Model: SP5		Date: 15-Oct-98	No.: 1
Modified Article: Parts Catalog		Prepared by: M. Tsuyuki	
From: GTS and S Field Information Dept.			
Reason for Modification:	☒ Parts catalog correction ☐ To facilitate assembly ☐ Part standardization	☐ Vendor change ☐ To improve reliability ☐ Other	☐ To meet standards ()

Model: SP5		Date: 31-Oct-98	No.: 2
Modified Article: Development Entrance Seal		Prepared by: A. Sasaki	
From: GTS and S Field Information Dept.			
Reason for Modification:	☐ Parts catalog correction ☐ To facilitate assembly ☐ Part standardization	☐ Vendor change ☒ To improve reliability ☐ Other	☐ To meet standards ()

Model: SP5/SP5L		Date: 15-Jan-99	No.: 5
Modified Article: Oil Supply Cleaning Roller		Prepared by: M.Tsuyuki	
From: GTSS Field Information Dept			
Reason for Modification:	☒ Parts catalog correction ☐ To facilitate assembly ☐ Part standardization	☐ Vendor change ☐ To improve reliability ☒ Other	☐ To meet standards ()

53. Drive Section 1 (A229)

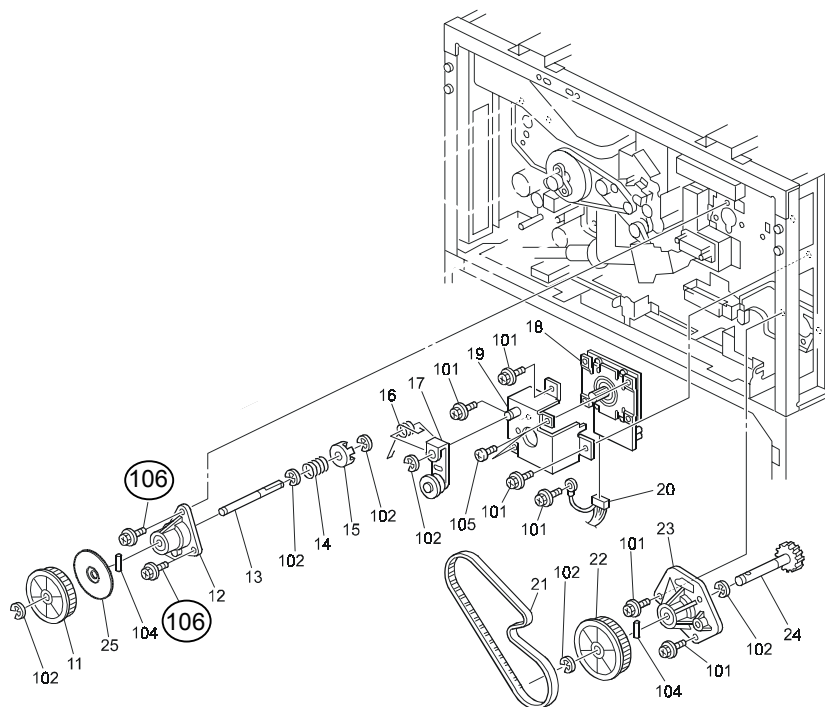
To facilitate assembly, the three screws securing the fusing drive bracket have been changed.

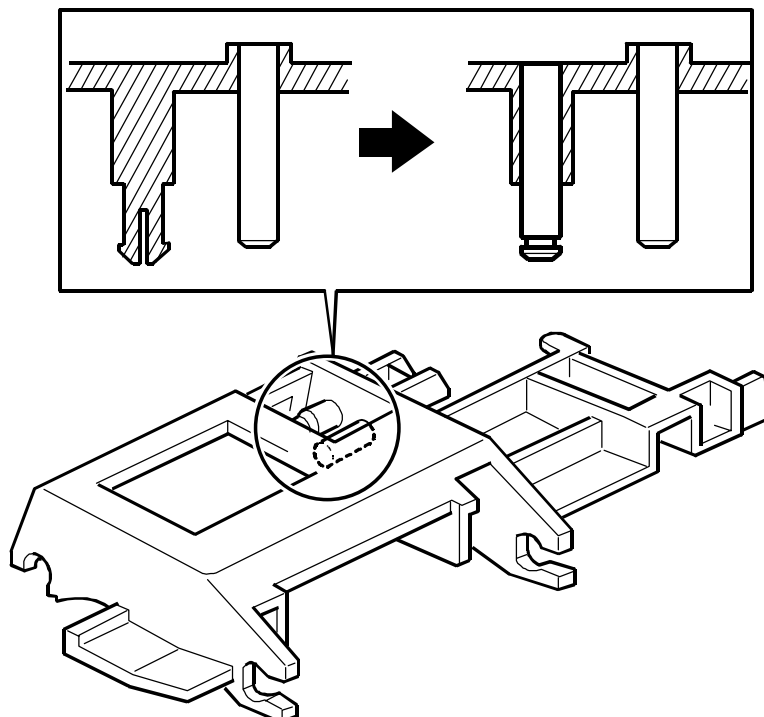
The Pick-up Roller Bracket has been changed for purposes of parts standardization with the new model. As shown below, the new bracket contains a metallic shaft for the timing pulley (A8062151) to improve the bracket's durability.

Old part number	New part number	Description	Q'ty	Int	Page	Index	Note
A8061314	B3011314	Pick-up Roller Bracket	1	X/O	25	17	*

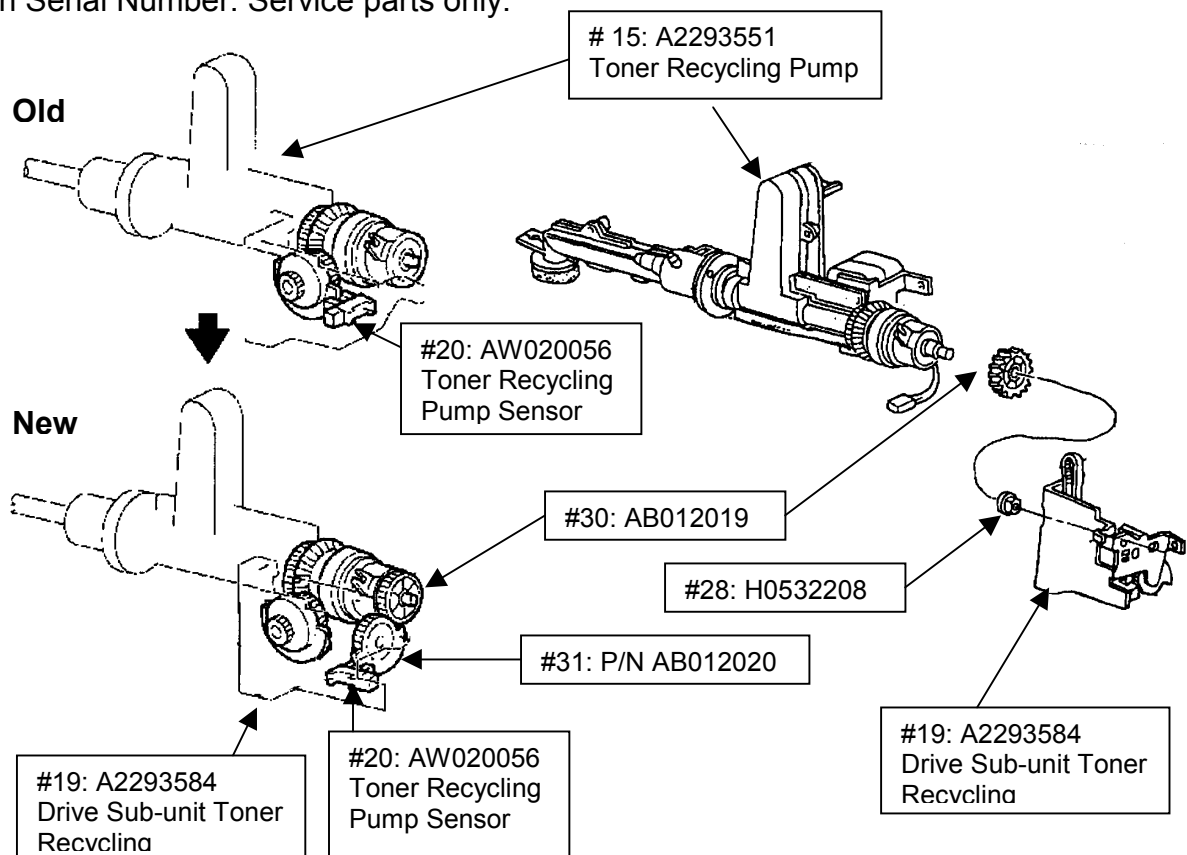
To improve the detection of the toner pump lock, the Toner Recycling unit has been changed as follows:

1. Changed the position of the Toner Recycling Pump Motor Sensor on the Bracket - Toner Recycling Drive.

Note: The bracket now contains an additional hole for the new sensor position, but the part number for the bracket has not been changed (A2293585).

2. Added two gears (index #30, 31 below).

Old part number	New part number	Description	Q'ty	Page	Index	Note
	AB012019	Gear – 25Z	1	123	30	
	AB012020	Gear – 28Z	1	123	31

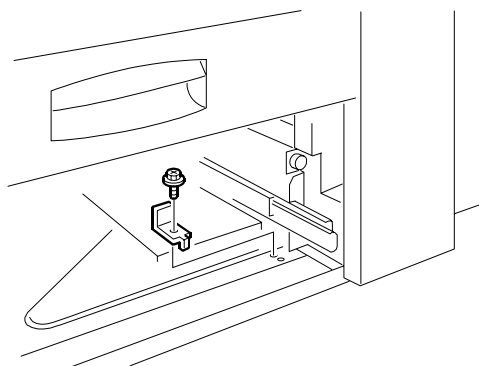
Please add the above part to the Aficio 650 parts catalog.

Old part number	New part number	Description	Q'ty	Int	Page	Index	Note
-	A0966819	3rd Tray Stopper Bracket	1	-	139	35

Pg. 138, 63 Frame Section 3 (A229), Indexes #9, 10.

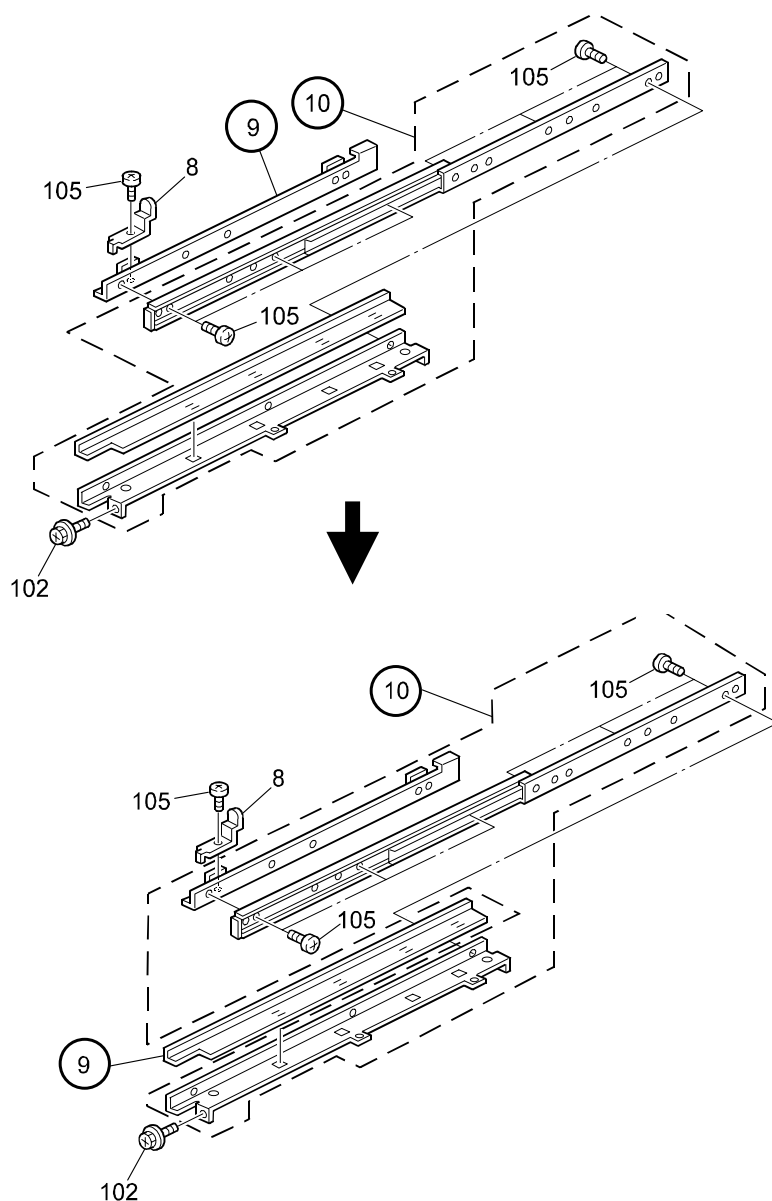
Illustration, Index Correction.

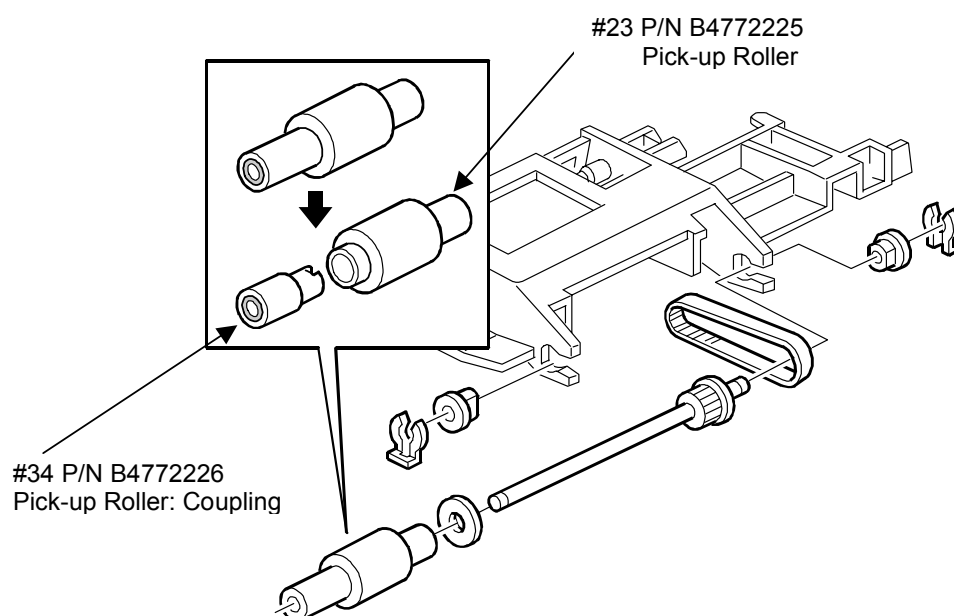
Old part number	New part number	Description	Q'ty	Int	Page	Index	Note
A8061321		Pick-up Roller	1 - 0	O/	25	23	
	B4772225	Pick-up Roller	0 - 1	/X	25	*23	
	B4772226	Pick-up Roller: Coupling	0 - 1	/X	25	*34

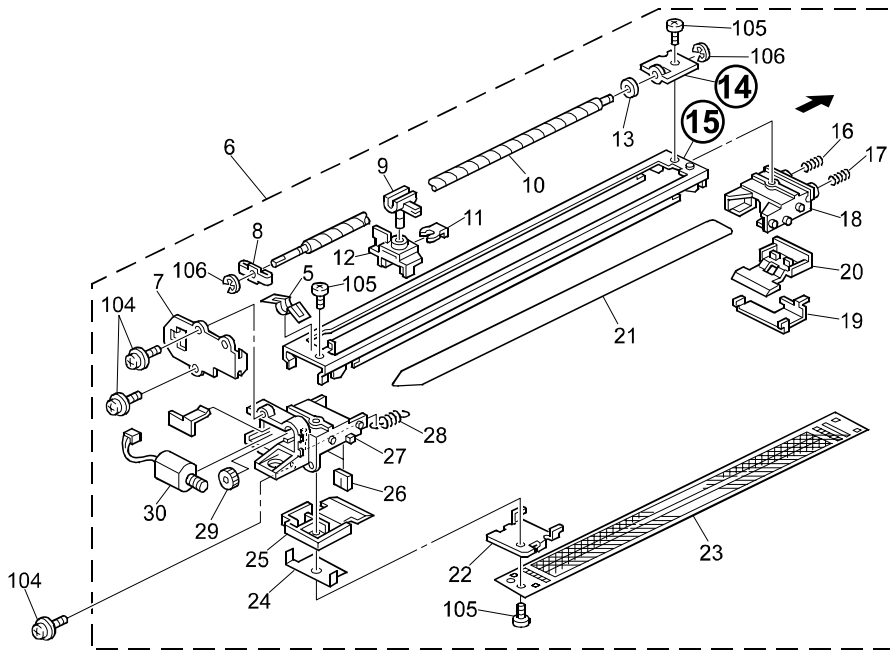
The following has been changed due to parts standardization with the Martini.

Old part number	New part number	Description	Q'ty	Int	Page	Index	Note
AA080148		Rear Bushing	1 - 1	O/O	85	14	*
	B1402291	Bushing: Screw Shaft: Rear					*
AD023106		Charge Corona Casing	1 - 1	O/O	85	15	*
	B1402292	Case: Charge Corona					*
